# DUNE-APA PCB Tolerance Change Request

DUNE APA Technical Board Meeting, 21st August 2023.

## Geometry Board Tolerances And Metrology Procedure Change Request

Requester: Justin Evans, Vitaly Kudryavtsev, Graham Miller, Pawel Guzowski & Anthony Ezeribe	Date: 31/03/2023
	Number: APA-PCB-09

Central Mounting Counterbored Hole Diameter in PCR-2.

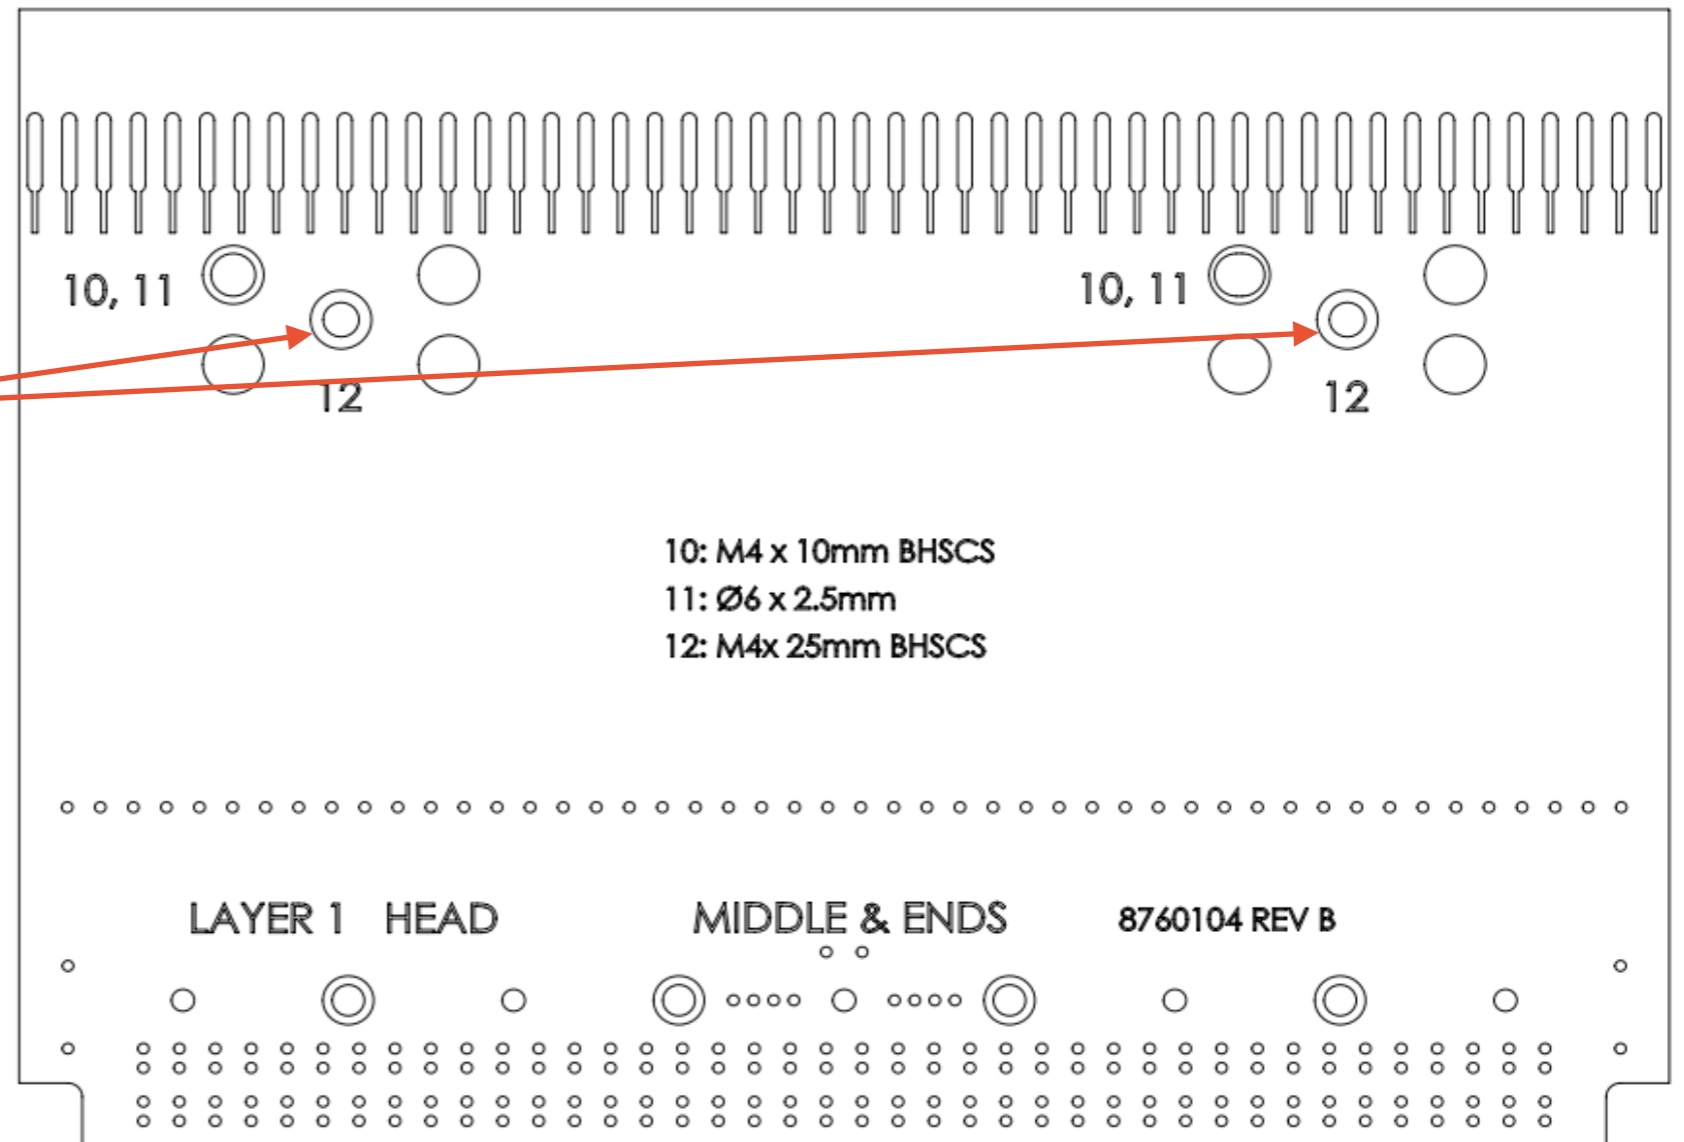
- Nominal head board central counterbore hole diameter is  $5.000 \pm 0.115$  mm, proposed for change to  $5.000^{+0.115}_{-0.500}$  mm. See **PCR-2** for details.
- The counterbore hole has not been made bigger to ensure that the head of the M4 screw locks the head board with enough FR4 material.
- The minimum possible clearance for an M4 screw is 4.3 mm but the minimum counterbore diameter is 4.5 mm.

To change the central counterbored hole diameter tolerances. These holes are marked "12" on each head board. The major constraining issues on these head board central counterbored hole diameter design are whether (a) the M4 screws in such holes will have enough FR4 materials to rest on when locked and (b) the screws will have enough clearance to pass through if the holes are made too small? Considering these

Are you certain the max material condition (proposed here to be changed from 4.9 to 4.5) is enough clearance? Keep in mind the position tolerance of hole(s) is also factor.

To ensure that there are enough FR4 materials to hold the head of the locked M4 screws, we have not made the hole bigger by not changing the maximum allowed counterbored hole diameter. The minimum allowed counterbored hole diameter for a given M4 screw is 4.3 mm. However, the proposed tolerance here allows a minimum counterbored hole diameter of 4.5 mm to ensure that the screws have enough clearance.

issues, we propose to change the head board central counterbored hole diameter tolerances from the current  $5.00 \pm 0.115$  mm to  $5^{+0.115}_{-0.500}$  mm.

Minimum lock material has not been changed so we consider this as **approved**.

# Head Board Epoxy Groove Depth

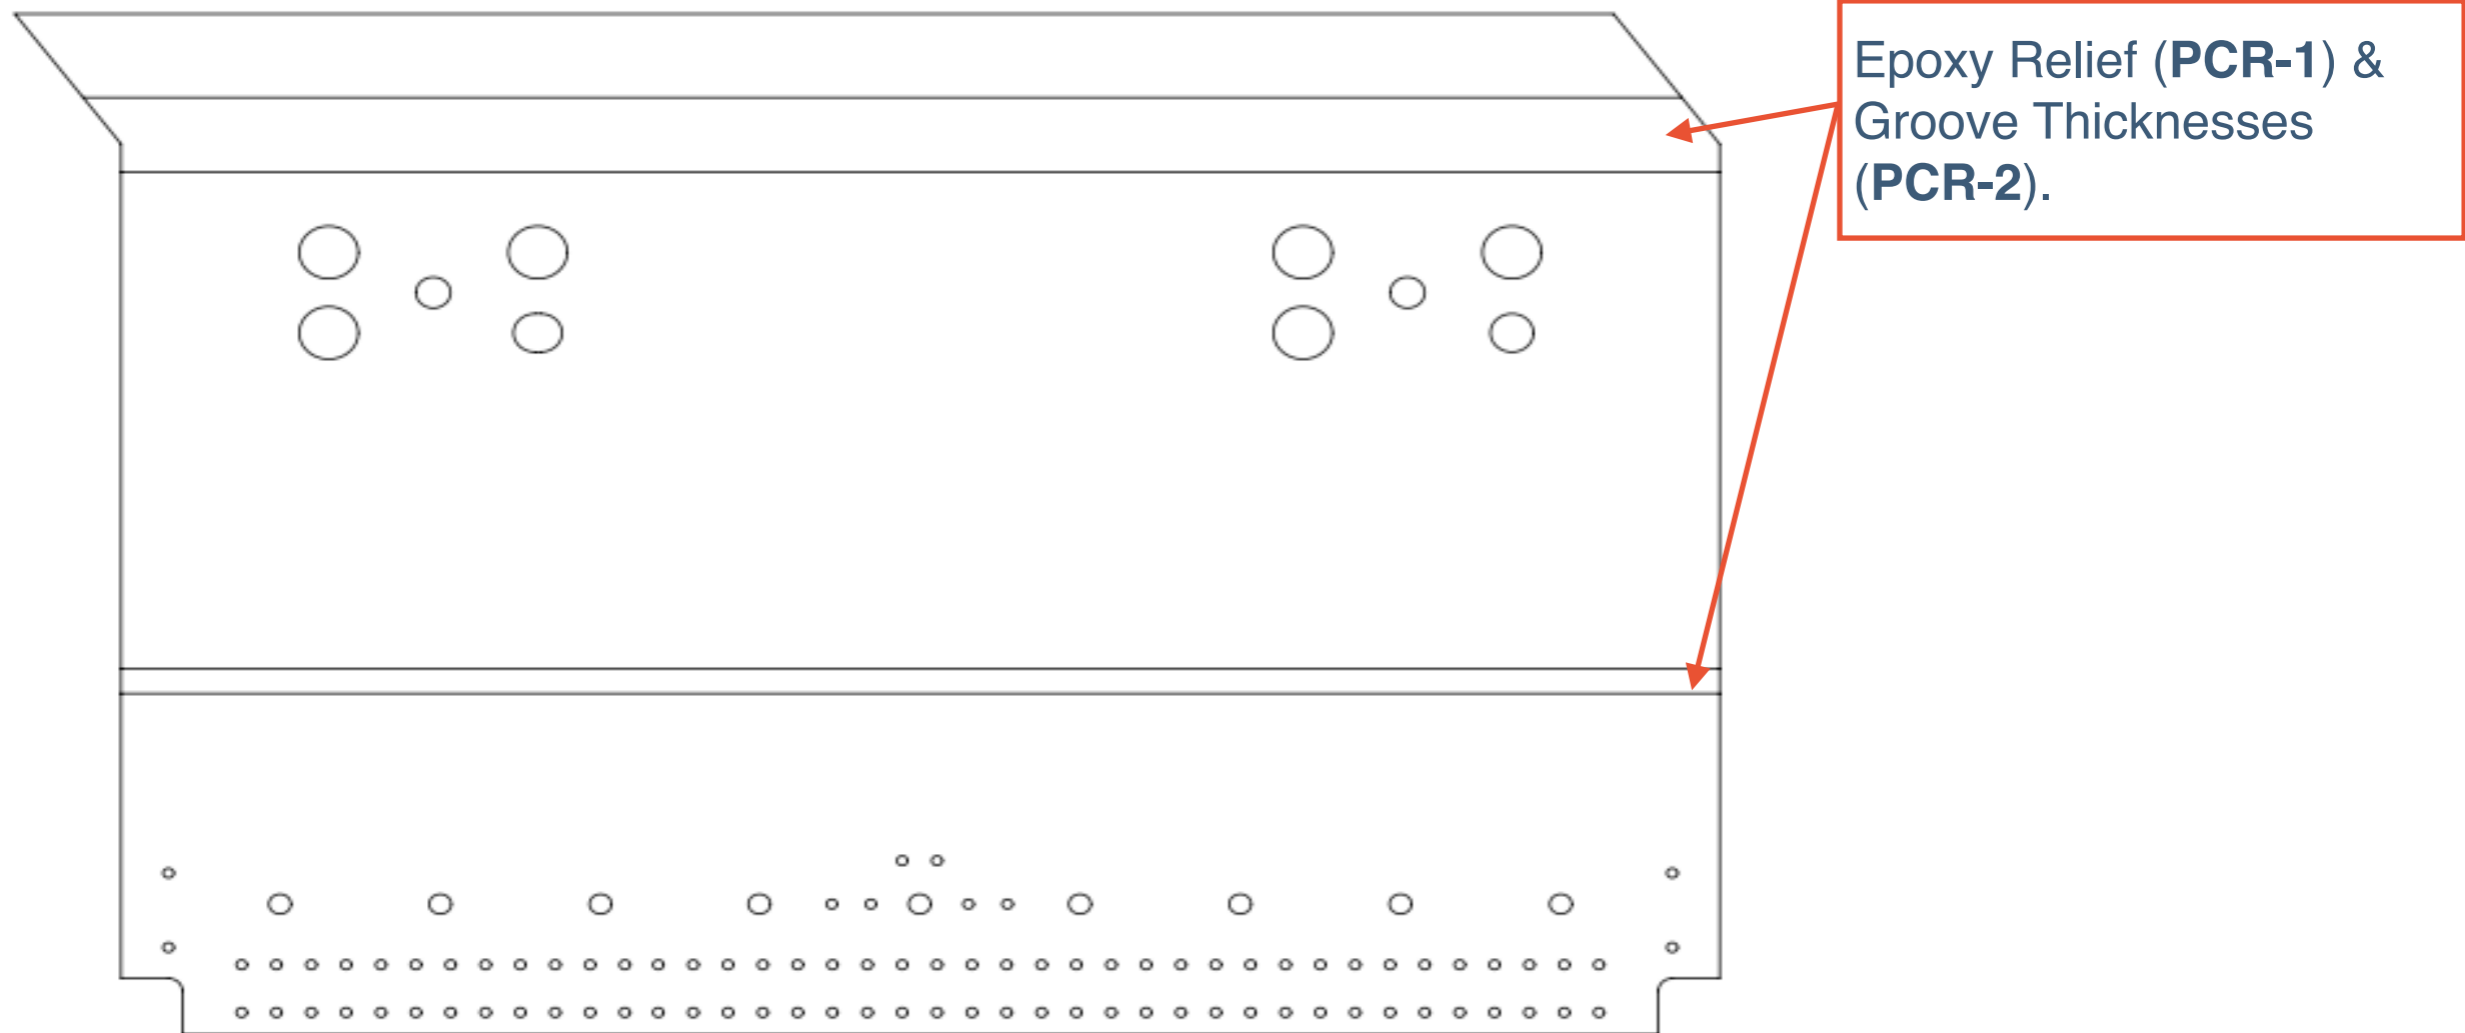
- The nominal **head board epoxy groove depth** is  $1.05^{+0.25}_{-0.20}$  mm, proposed for change to  $1.05^{+0.45}_{-0.25}$  mm.
- The nominal **head board epoxy relief depth** is  $0.25 \pm 0.15$  mm, proposed for change to  $0.25^{+0.3}_{-0.18}$  mm.
- The proposed tolerances will allow a minimum head board epoxy groove volume of  $230 \times 5 \times 0.8 \text{ mm}^3$  with a maximum groove volume of  $230 \times 10 \times 1.5 \text{ mm}^3$  expected to be enough to stop epoxy from reaching the MM pins.
- The maximum expected tension on each head board is **~336 N** (7N x 48 wires) which is well below the expected **~1190 N** limit of a head board with the  $230 \times 10 \times 1.5 \text{ mm}^3$  epoxy groove (worst case).

The relief mentioned here is not used to provide a reservoir to stop/collect epoxy before it can spread to the mill-max pins. The relief is filled with epoxy to bond the wires to the board surfaces above and below. The amount of epoxy needed to fill the gap was carefully studied. Current volume to fill has a depth of  $0.25 \pm 0.15$  (+/-60%).

The change requested is  $0.25 + 0.3 / - 0.18$  (+120%/-72%). With this wider range it is uncertain if the epoxy will completely fill and fully cover the wire length thus affecting the bond.

<p>Is there a typo in here?</p> <p>Shear strength?</p> <p>Similar to the other request on a different document: The relief mentioned here is not used to provide a reservoir to stop/collect epoxy before it can spread to the mill-max pins. The relief is filled with epoxy to encapsulate the solder and solder flux to keep LAr clean. Some of the epoxy is intended to spread into the gap that bonds the wire. The amount of epoxy needed to fill the gap was carefully studied.</p> <p>The change requested has a wider range it is uncertain if the epoxy will completely fill and fully cover solder pads and spread into the wire bond area properly.</p>	<p>Please follow the naming and numbering convention defined in the instructions at EDMS 2709827</p> <p>Reference number changed</p> <p>Minimum width from grooves on V-head boards.</p> <p>Flexural strength: resistance to bend deformation</p> <p>Shear strength: resistance to shear deformation</p> <p>Considered as Not Approved: Can PSL test the proposed dimensions and advise us?</p>

Considered as Not Approved:  
Can PSL test the proposed dimensions and advise us?

# Wrap Board Thickness And Tongue Thickness

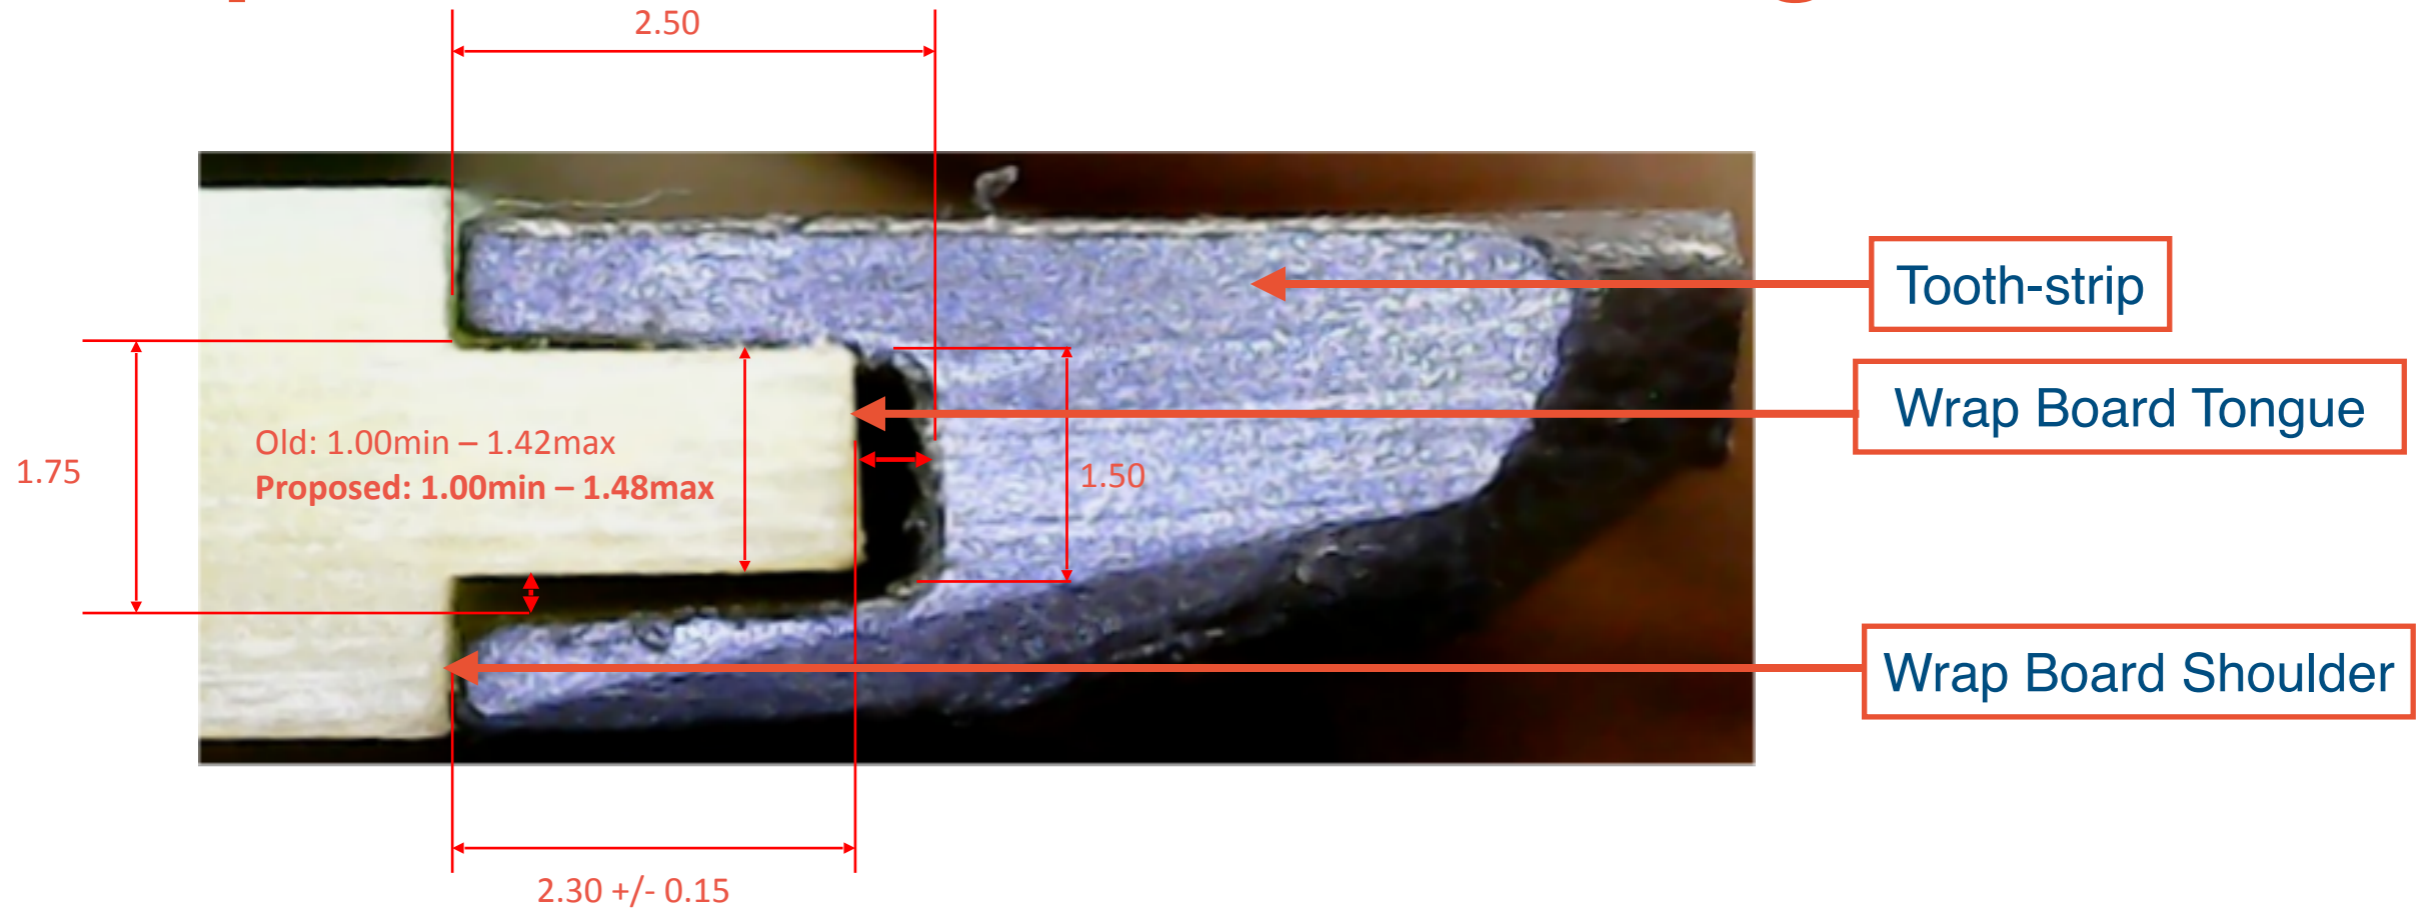
- The proposal is to change the current wrap board thickness tolerance from  $3.18 \pm 0.159$  mm (5%) to  $3.18^{+0.160}_{-0.318}$  mm (i.e. +5%) (i.e. -10%). See **PCR-2** for details.
- The +5% upper thickness range was needed to ensure that gaps between adjacent APAs in the cryostat are maintained.
- The proposed -10% lower thickness range will not affect the position as the wire layer as this is determined by the wrap board tongue shoulder position and the finished height of an assembled wrap board.
- The proposal is to change the current **wrap board tongue thickness** tolerance from  $1.18^{+0.24}_{-0.18}$  mm to  $1.18^{+0.30}_{-0.18}$  mm. The proposed upper tongue thickness ensures a clearance of at least  $20 \mu\text{m}$  from the maximum tooth-strip top-end groove. See **PCR-2** for details.

To change the tolerance on wrap board thicknesses. Wrap boards are attached on the side and foot end of an APA frame to maintain the wire pitch all through an APA. Thicker wrap boards are expected to close up the clearance between adjacent APAs in the Cryostat. Hence, we propose to change the current tolerance on wrap board thickness from  $3.18 \pm 0.159$  mm to  $3.18^{+0.160}_{-0.318}$  mm.

Edges of the wrap boards are cantilevered beyond the width of the tube. The support is only that of the flat surface and does not include the tube radius. The strength and stiffness of the board (with cantilevered wire load) must be checked before allowing thinner boards.

Wrap Board Mounting Slot Hole

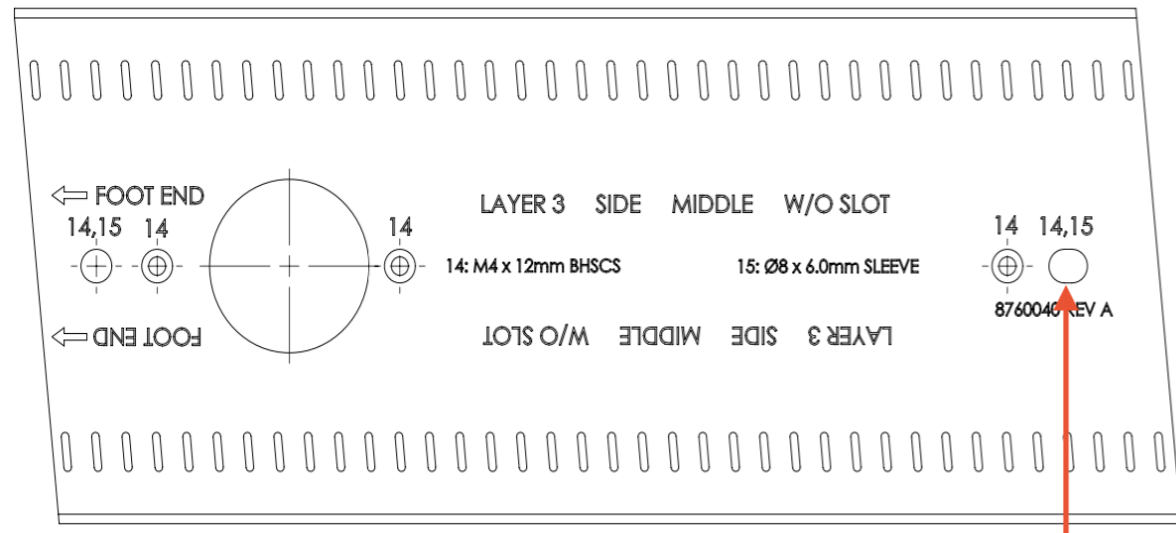
- The proposal is to change the current wrap board mounting slot width tolerance from  $10.15^{+0.20}_{-0.11}$  mm to **10.15 ± 0.25** mm. See **PCR-1** for more details.
- Wrap board **slot height** affects the wire layer position and not the **slot widths!** Slot widths are needed to position the wrap boards in the horizontal direction so no issue is expected from the 50 – 140 μm change.
- The proposal is to change the current wrap board cable conduit D-cut edge radius from  $7.00 ± 0.45$  mm to **7.00 ± 0.70** mm. See **PCR-2** for more details.
- The proposed wrap board cable conduit D-cut edge radius tolerance will leave **at least a clearance of 300 μm** (in the worst case) between the main APA wire conduit hole and edge of the wrap board D-cut hole.

The current tolerance on wrap board mounting holes is +200  $\mu\text{m}$  and -110  $\mu\text{m}$ . We propose to change this to  $\pm 250 \mu\text{m}$  as what matters most to the APA assembly team is the slot heights and not the width of the slots

The requested change does not affect the location of the board. The change is okay as long as the distance minimum distance between the slot edge and board traces meets requirements.

Hole to trace clearance meets IPC 2221 requirement so we consider this as **Approved**.

Wrap Board D-Cut Cable Conduit Hole

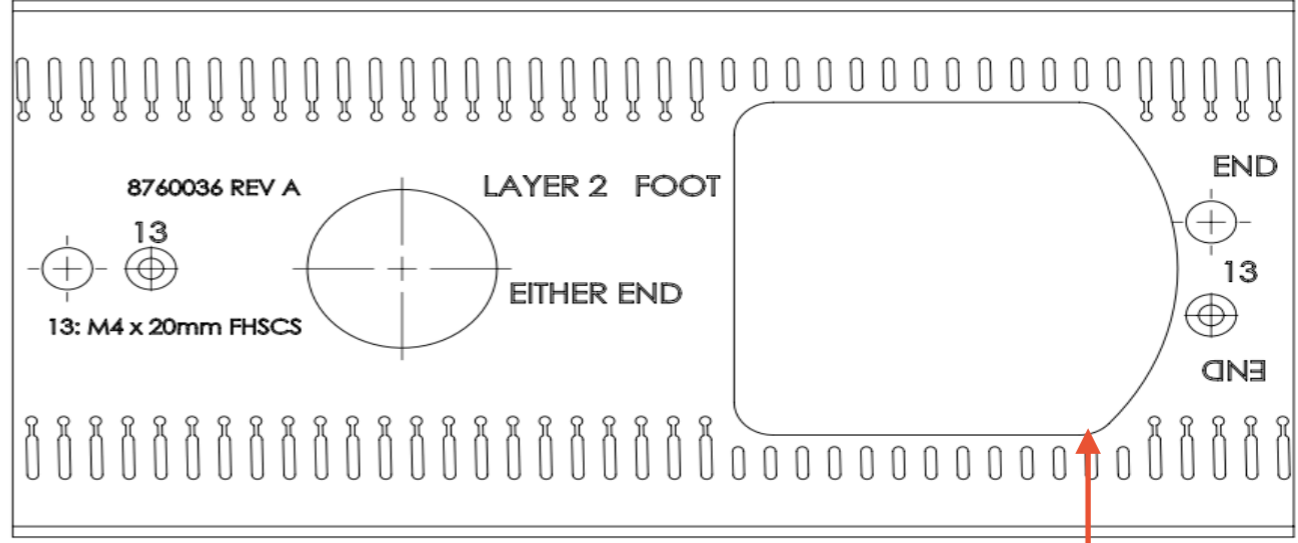
To change the wrap board cable conduit D-cut edge radius tolerances. These are the edge radius of the D-cut holes for the installation of cable conduit pipes on an APA. The major constraining issues on these cable conduit D-cut edge radius design are whether any changes in tolerances will obstruct the cable conduit pipe installation process? The current tolerance on these wrap board cable conduit D-cut edge radius is  $7 \pm 0.45$  mm which allows a clearance of  $\sim 1$  mm from the main APA cable conduit D-cut hole and the edge of the wrap board cable conduit D-cut hole. Hence, we propose to change these wrap board cable conduit D-cut edge radius tolerance to  $7 \pm 0.70$  mm.

The proposed wrap board cable conduit D-cut edge radius tolerances will leave a clearance of at least  $300 \mu\text{m}$  (in the worst case) between the edge of the main APA cable conduit D-cut hole and edge of the wrap board cable conduit D-cut hole. So the proposed changes will still allow for a smooth installation of the cable conduit pipes without any expected interference.

Okay, the proposed change does not violate minimum distance from edge to traces.

Approved.
